Application No.: 09/753,764
Amendment dated: April 13, 2005
Reply to Office Action Dated: January 13, 2005

REMARKS/ARGUMENTS

AMENDMENTS TO THE DRAWINGS

FIG. 3

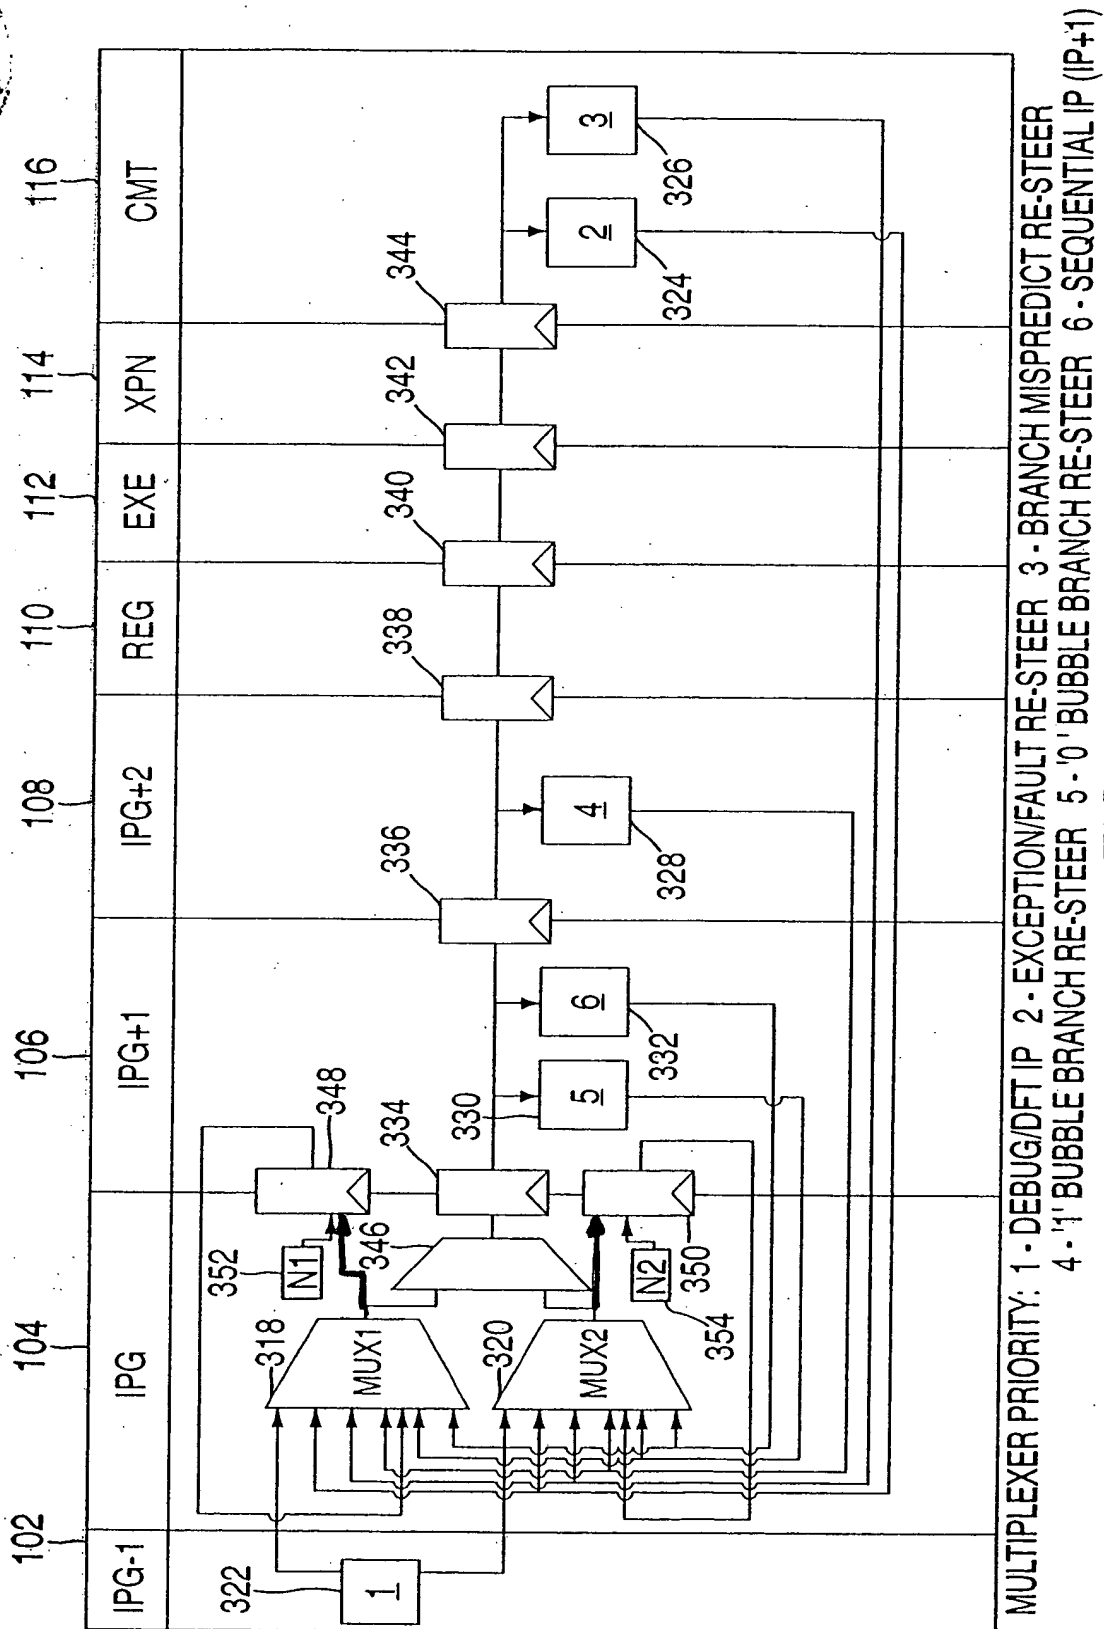
Figure 3 has been amended to reintroduce connecting arrows pointing from multiplexer 318 to storage element 348 and from multiplexer 320 to storage element 350. These connecting arrows were present in Figure 3 as originally filed, but were accidentally left off the formalized drawings.

The attached sheets of drawings include changes to Figure 3. Connecting arrows pointing from multiplexer 318 to storage element 348 and from multiplexer 320 to storage element 350 have been reintroduced to Figure 3. These connecting arrows were present in Figure 3 as originally filed, but were accidentally left off the formalized drawings.
